Reference: Oregon State University TRIGA Reactor (OSTR)
Docket No. 50-243, License No. R-106
Request for Additional Information (RAI) Regarding License Renewal, Oregon
State University TRIGA Reactor (TAC NO. MC5155) dated May 21, 2007

Subject: Additional Oregon State University Response to RAI Regarding License Renewal,
Oregon State University TRIGA Reactor dated May 21, 2007

Further Responses to RAI Letter of May 21, 2007

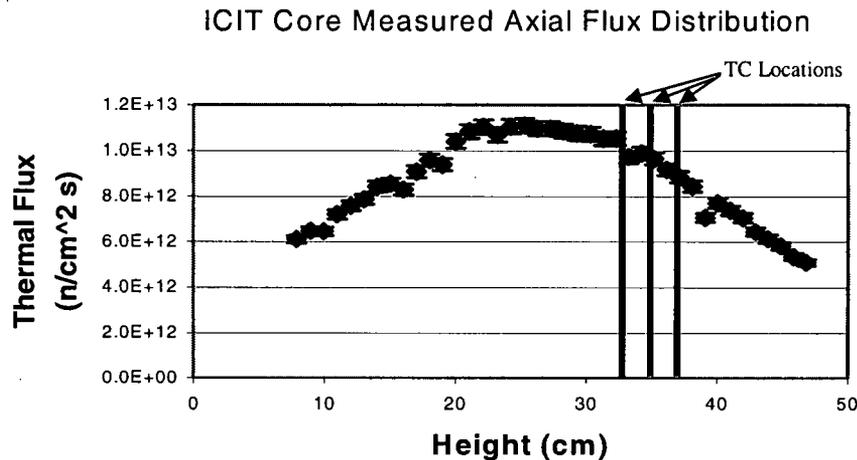
3. **What is the maximum fuel element power for possible core loadings (#8)? What are the peaking factors? Tables 4-11 and 4-12 only contain average power per element.**

The power per fuel element was calculated using MCNP5 with a model for a core similar to core #8 at a power of 1.1 MW. The new (MCNP5) model represents the reference HEU core (i.e., the original core loaded in 1976) and contains 4 less elements than core #8. The MCNP5 model for the reference HEU core was found to have very good predictive capability over a wide range of reactor conditions and was deemed to be well-suited for performing neutronics calculations. The results of this model can be seen in the following table:
